ENVIRONMENTAL ASSESSMENT REPORT

South Hercules Mine

Minerals and Metals Group (MMG) Rosebery

Report and recommendations of the
EPA Division
Department of Primary Industries, Parks, Water and
Environment

Figure 1: General site plan (Figure 2 of the DPMP)

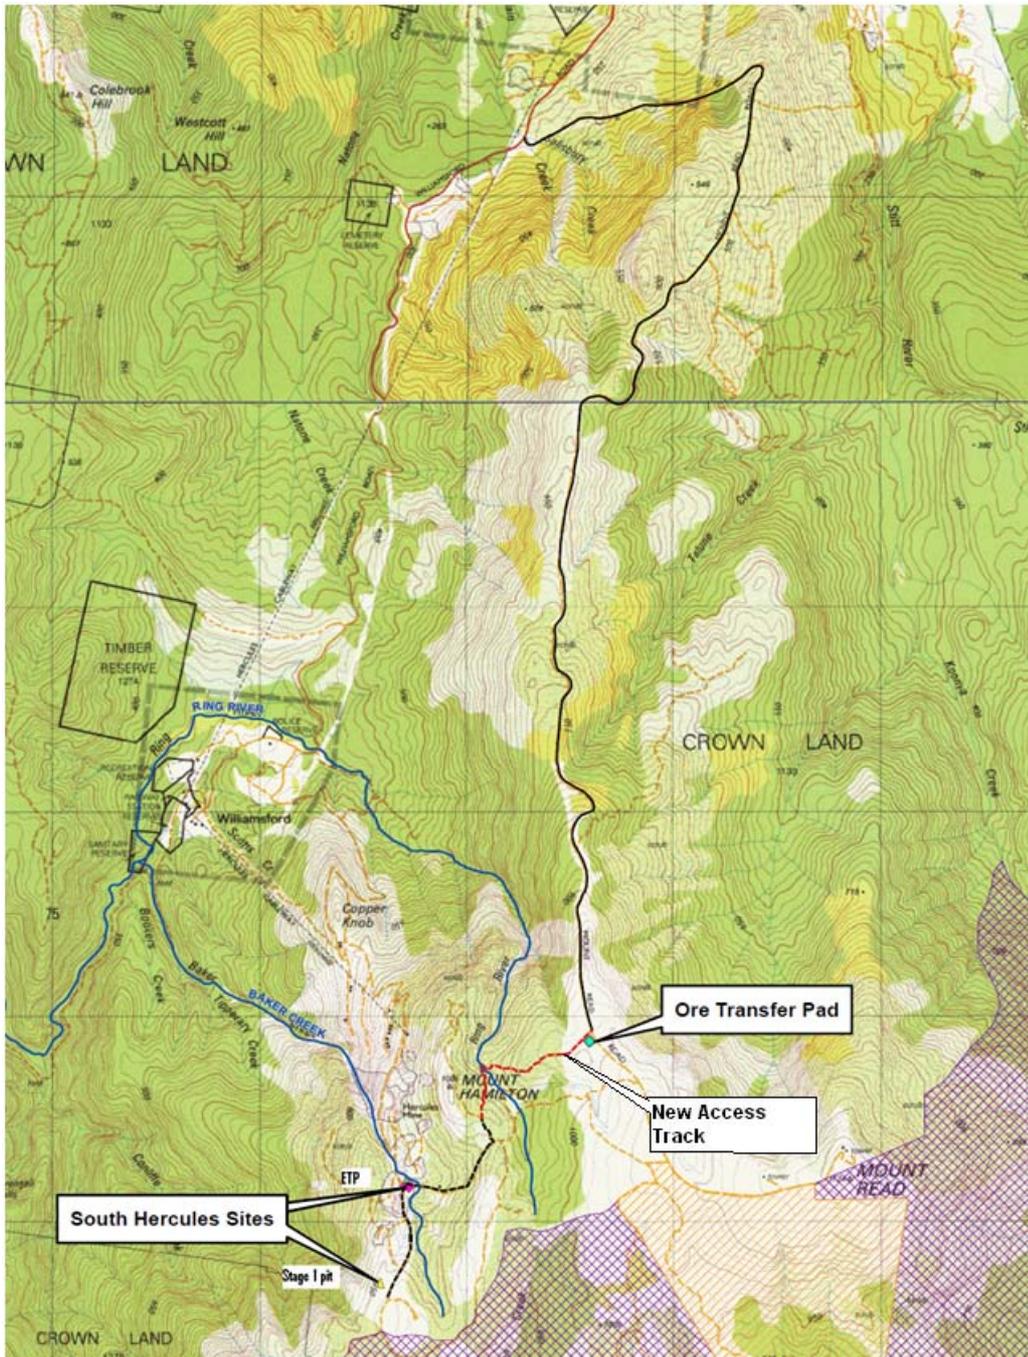
Rather than upgrade existing tracks through an area of *Athrotaxis selaginoides-Nothofagus gunnii* short rainforest (RKF), the DPEMP proposes construction of a new AWD access road (refer to Figure 1) through non-threatened vegetation types.

Figure 2: Effluent treatment process overview (Figure 6 of the DPMP).

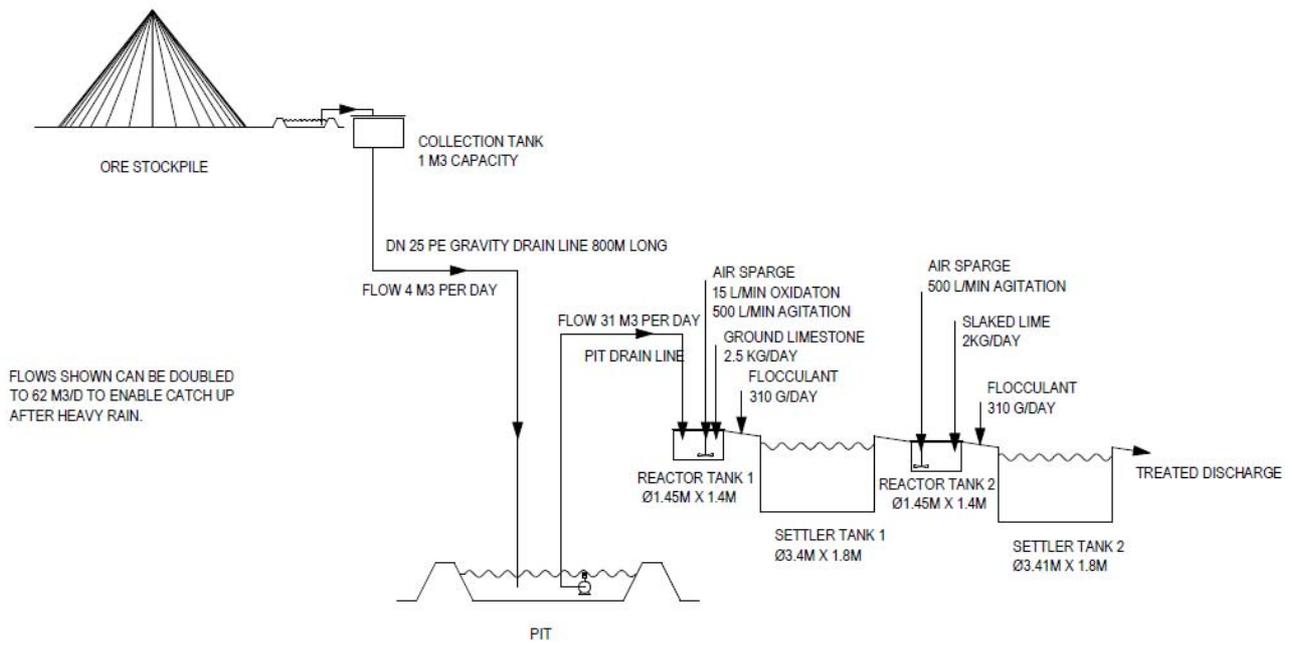
The DPEMP indicates that Phase 1 construction and mining is to be completed within a period of approximately 3 months. This is generally considered a very short period of time for development of substantial AMD conditions. The proposed two-stage effluent treatment plant is therefore considered adequate to neutralise any AMD generated during Phase 1.

Neutralisation of acid alone will not achieve the desired environmental protection. It is most important that metal hydroxide precipitates are collected and retained, otherwise they will simply redissolve in the acidic conditions known to exist downstream of the South Hercules site.

The first stage of effluent treatment involving addition of ground limestone along with aeration and addition of flocculant, coupled with a second stage involving addition of slaked lime (Ca(OH)₂) and

further settling, is considered to represent best practice for the treatment of unavoidable AMD, providing that a pH of 8.5 is achieved and residence time is sufficient to allow settling of all precipitates. The Scientific Officer (Water) recommended inclusion of a limit on discharge of total suspended solids (**Conditions E2 and E3**).

The Scientific Officer (Water) notes that it may take some experimentation in order to achieve the correct settings for the effluent treatment plant. This may be difficult during such a short period of operations, however the knowledge gained may prove invaluable for future treatment of AMD.
